Final Assessment Letter on TAR

CITY OF LOS ANGELES  
INTER-DEPARTMENTAL CORRESPONDENCE15134 S Vermont Ave  
DOT Case No. HRB19-108453

Subject: **REVISED TRANSPORTATION IMPACT ASSESSMENT FOR THE PROPOSED INDUSTRIAL  
USE PROJECT AT 15134 SOUTH VERMONT AVENUE**

FIGURE 2-2  
SITE PLAN

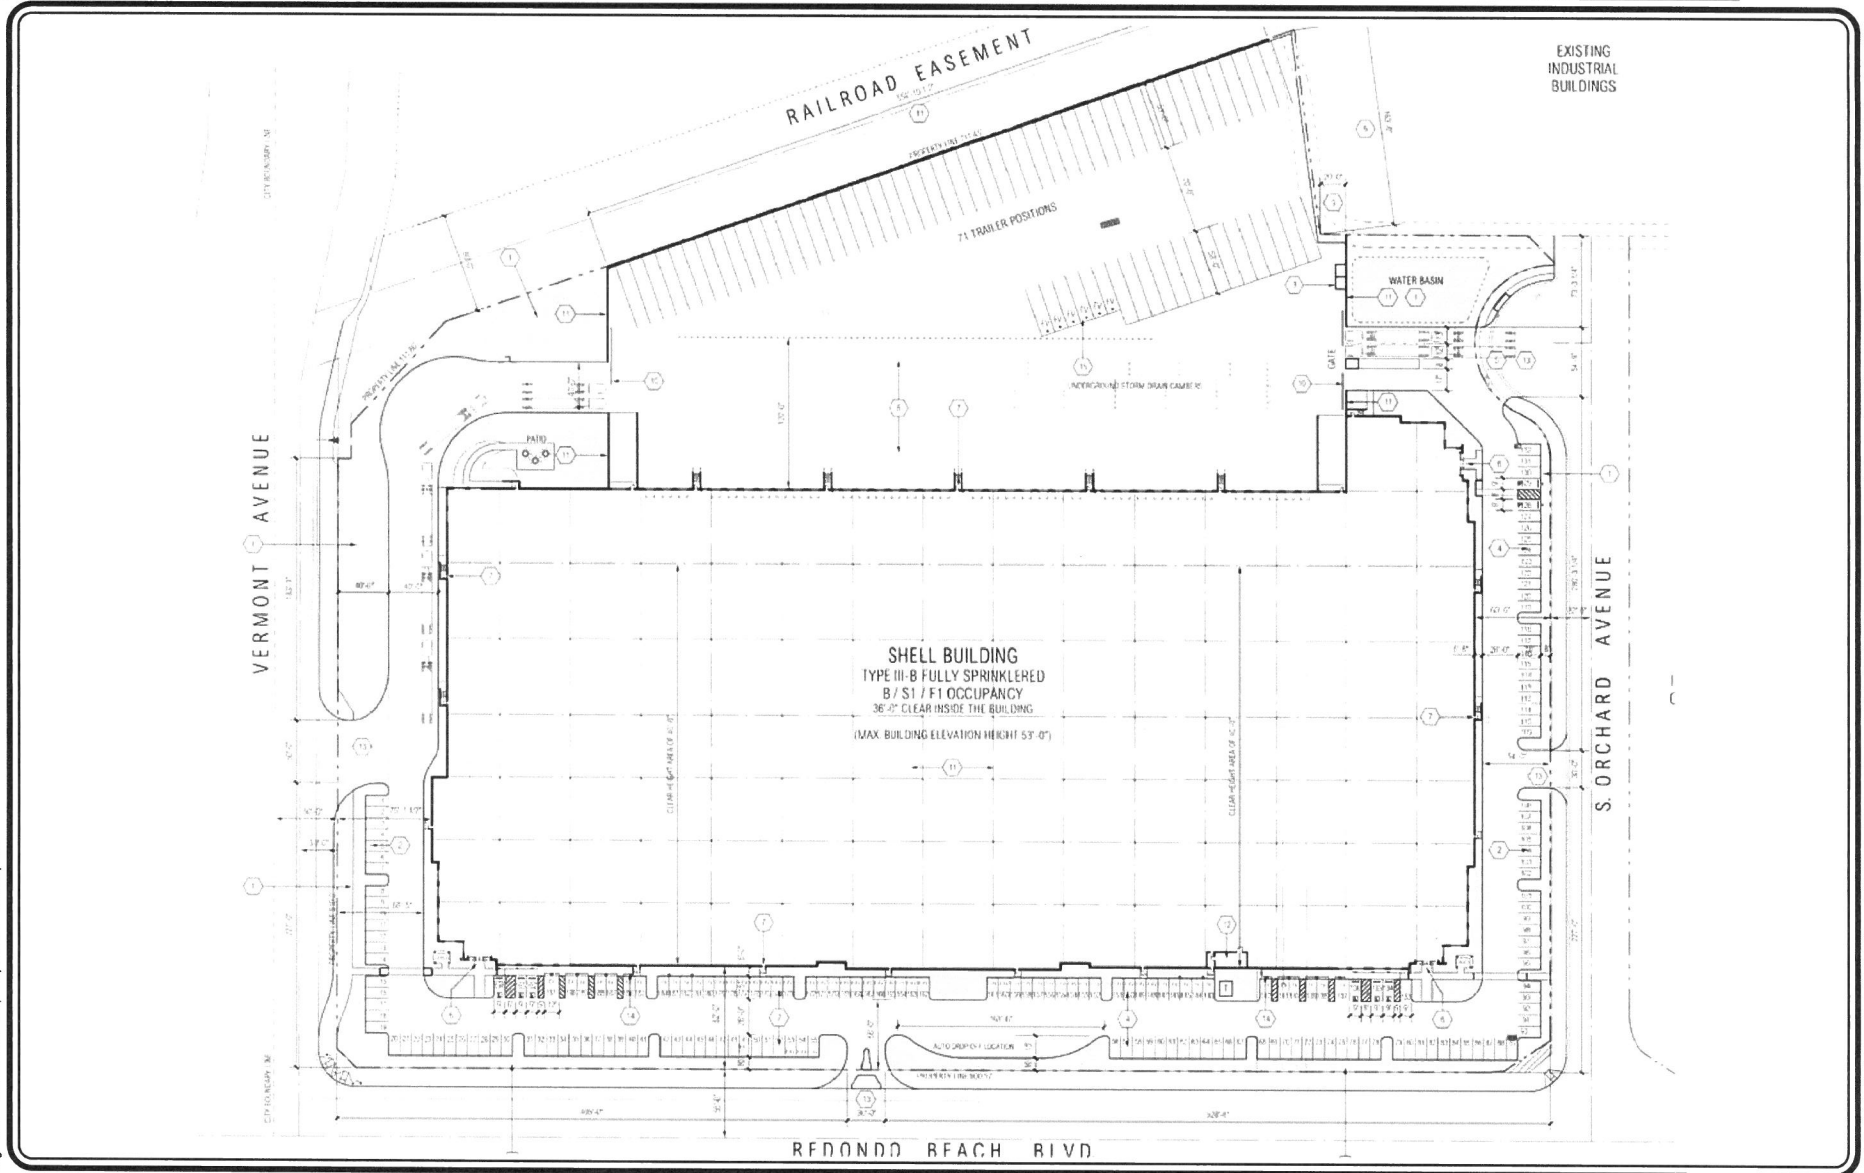
The project proposes to construct a single story structure to provide a total of 340,298 square feet of industrial space located at 15134 Vermont Avenue. The existing site is currently vacant and is generally bounded by Redondo Beach Boulevard to the south, Orchard Avenue to the east, railroad tracks to the north and Vermont Avenue to the west. Access to the site will be provided via a driveway on Vermont Avenue, a driveway on Redondo Beach Boulevard and two driveways on Orchard Avenue as illustrated in (Figure 2-2) **Attachment A**. The project is expected to be completed by 2022.

The proposed site plan is acceptable to DOT; however, review of the study does not constitute approval of the driveway dimensions and internal circulation schemes. Those require separate review and approval and should be coordinated with DOT's West LA/Coastal Development Review Section (7166 W Manchester Ave, @ 213-485-1062). In order to minimize potential building design changes, the applicant should contact DOT for driveway width and internal circulation requirements so that such traffic flow considerations are designed and incorporated early into the building and parking layout plans. All new driveways should be Case 2 driveways and any security gates should be a minimum 20 feet from the property line. All truck loading and unloading should take place on site with no vehicles backing into the project from public streets via any of the project driveways.
